Important information to Dealer shops and Garages

Concerning Xenon D1S for SAAB 9-5 model year 2003-2010

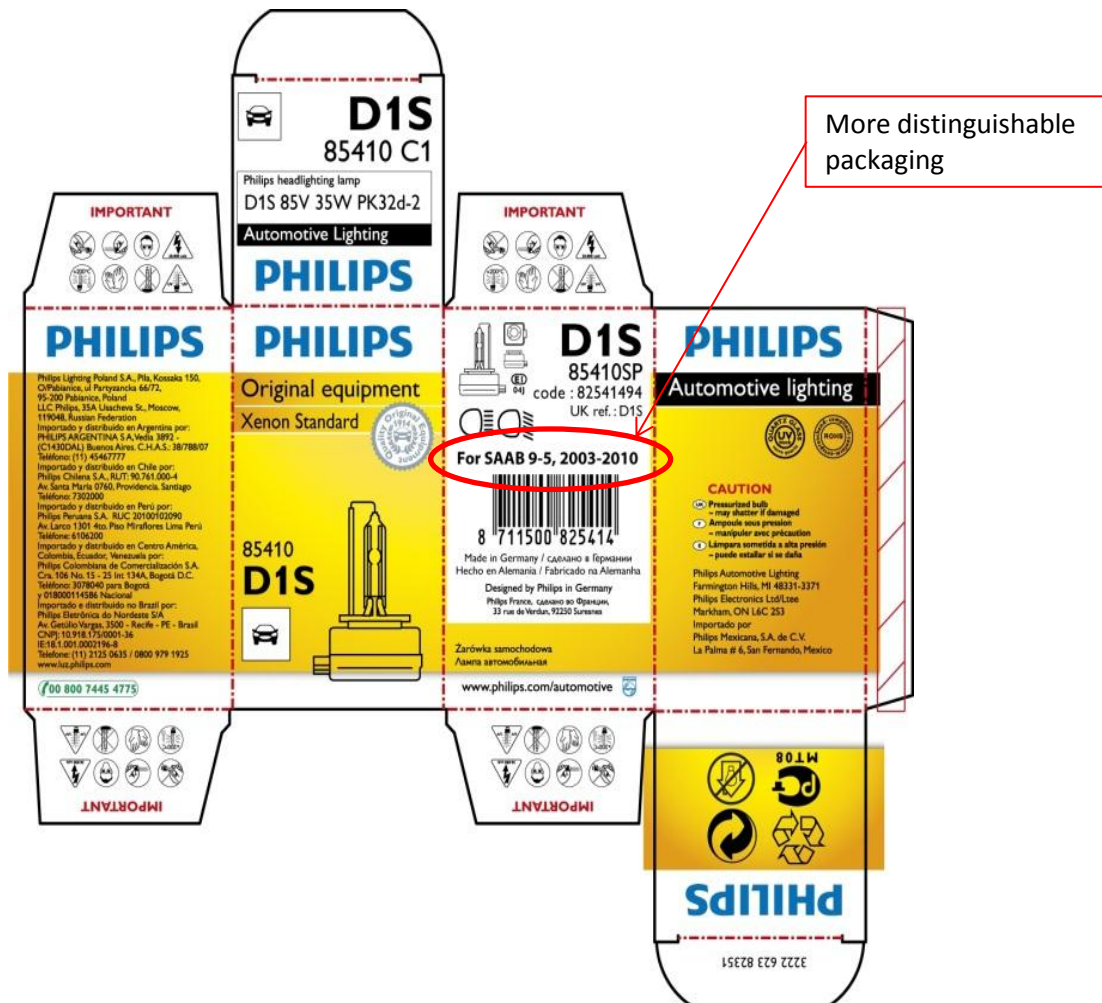
During 2006 a problem with Xenon lamps was discovered concerning above mentioned car models . After approximately half of the lamp life time (1000 h – 1500 h) it starts to flicker and blink and within a short period of time the lamp will stop working . This issue is caused by the electronic system and ballast in the car and therefore cannot be deduced to the lamp itself.

- To be able to offer our end consumers a safe and reliable product **we recommend to always use the Philips lamp in all situations when changing lamps.**
- To ensure that the correct lamp is mounted in the car the 10 digit part number is printed on the bottom of the lamp. **9285.147.294**. See below.
- Philips is today the only supplier providing this special Xenon lamp.

This denotes the special Saab lamp. It is marked with147....

To solve the issue and ensure a safe and secure ride, Saab has in cooperation with Philips developed a special Xenon lamp . This Xenon lamp can handle this particular electronic system in the car and will consequently last the full expected life time. The lamp has been available on the market for some time, however this information has not been recieved by dealers , garages or consumers.
